EPC PACKAGE FOR LARA SUPER THERMAL POWER PROJECT, STAGE-II (2x800 MW)
Amendment No. 05 to Technical Specifications Section-VI of Bidding Document No.: CS-9587-001R-2

Doc. No.: CS-9587-001R-2-TECH AMDT- 05	LARA SUPER THERMAL POWER PROJECT STAGE-II (2X800 MW)	Amendment No. 05 to Technical Specifications Section-VI
--	---	---

TITLE	SCHEME OF CIRCULATING WATER SYSTEM
-------	------------------------------------

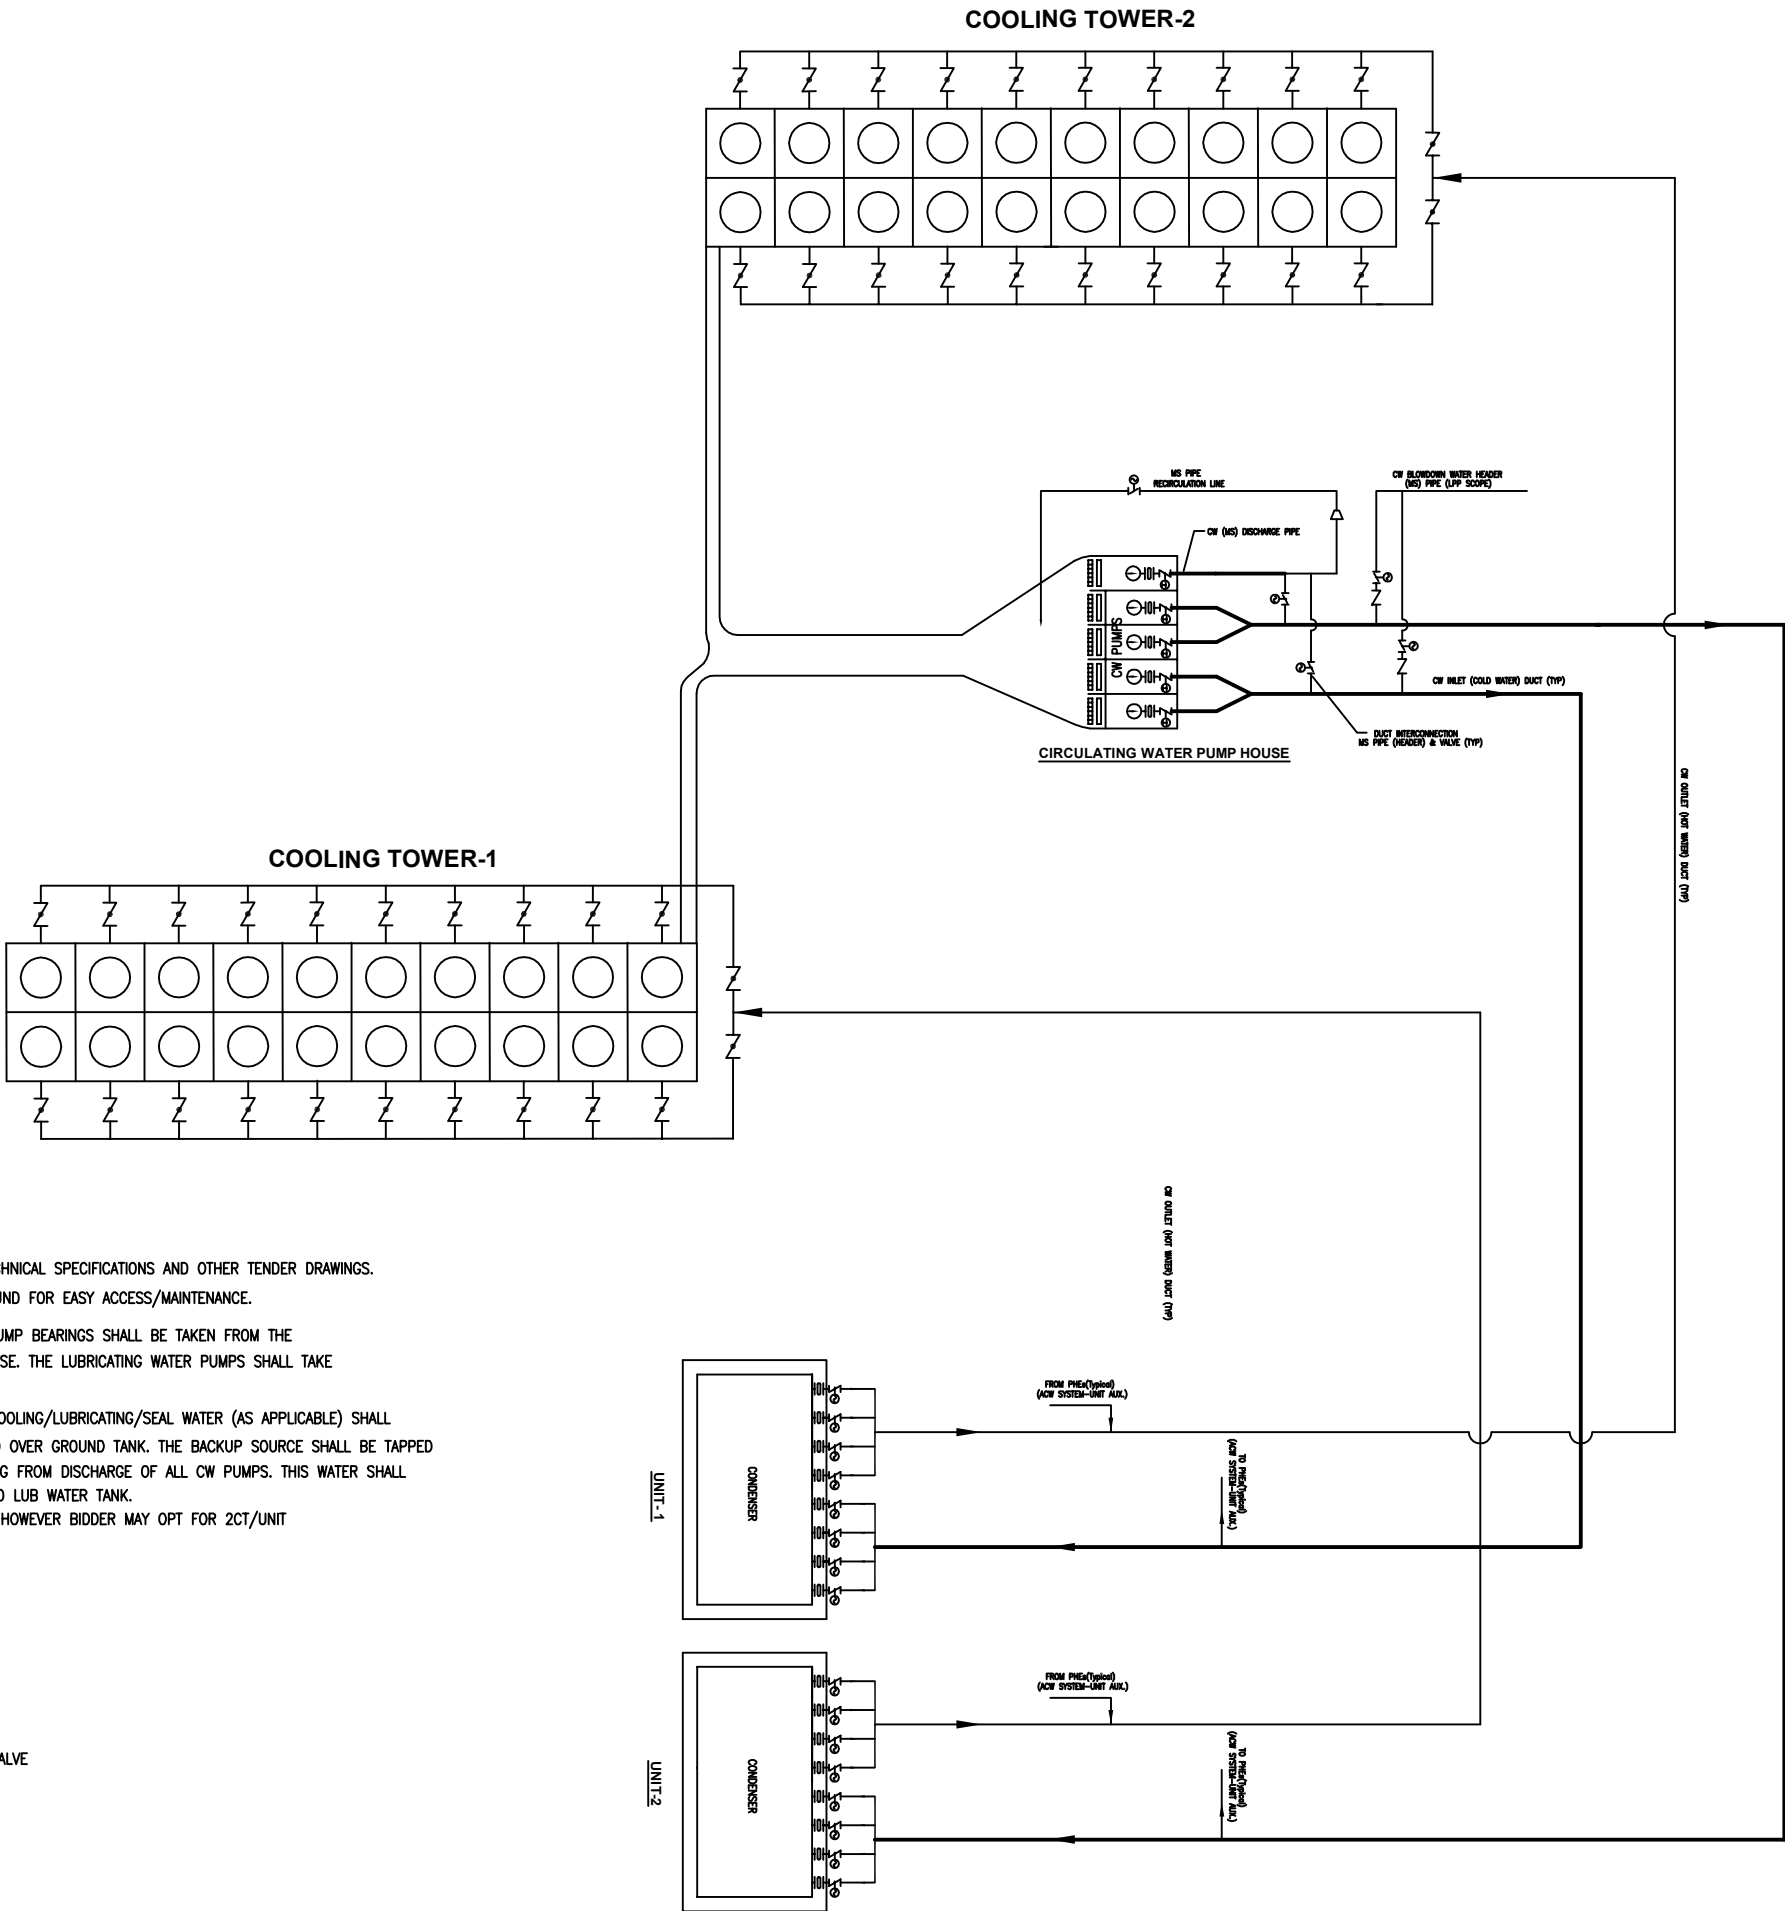
WS4-04	VI/B	A-01	3.02.00 a)	57 OF 101	Number of Cooling Towers: Two (2) numbers (One Number / Unit)	Number of Cooling Towers: Two (2) numbers (One Number / Unit) or Four (4) numbers (Two Numbers / Unit) as per configuration
WS4-05	VI/E	-	-	-	Tender Drawing “Scheme of Circulating Water System Rev A”	Tender drawing replaced with revised “Scheme of Circulating Water System Rev B”

1. THIS DRG. SHOULD BE READ IN CONJUNCTION WITH TECHNICAL SPECIFICATIONS AND OTHER TENDER DRAWINGS.
2. ALL THE VALVES SHALL PREFERABLY BE LAID OVERGROUND FOR EASY ACCESS/MAINTENANCE.
3. THE LUBRICATING / SEAL WATER REQUIRED FOR THE PUMP BEARINGS SHALL BE TAKEN FROM THE STORAGE TANKS TO BE PROVIDED NEAR THE PUMP HOUSE. THE LUBRICATING WATER PUMPS SHALL TAKE SUCTION FROM OVERGROUND STORAGE TANK.
4. DURING INITIAL FILLING AND NORMAL OPERATION, THE COOLING/LUBRICATING/SEAL WATER (AS APPLICABLE) SHALL BE TAPPED FROM NEAREST WATER SOURCE AND FED TO OVER GROUND TANK. THE BACKUP SOURCE SHALL BE TAPPED FROM A COMMON HEADER FORMED BY TAKING A TAPPING FROM DISCHARGE OF ALL CW PUMPS. THIS WATER SHALL PASS THROUGH 2 X 100% DUPLEX FILTERS AND FED TO LUB WATER TANK.
5. THIS DRG IS INDICATIVE FOR 1CT/UNIT CONFIGURATION, HOWEVER BIDDER MAY OPT FOR 2CT/UNIT CONFIGURATION AS SPECIFIED ELSEWHERE.
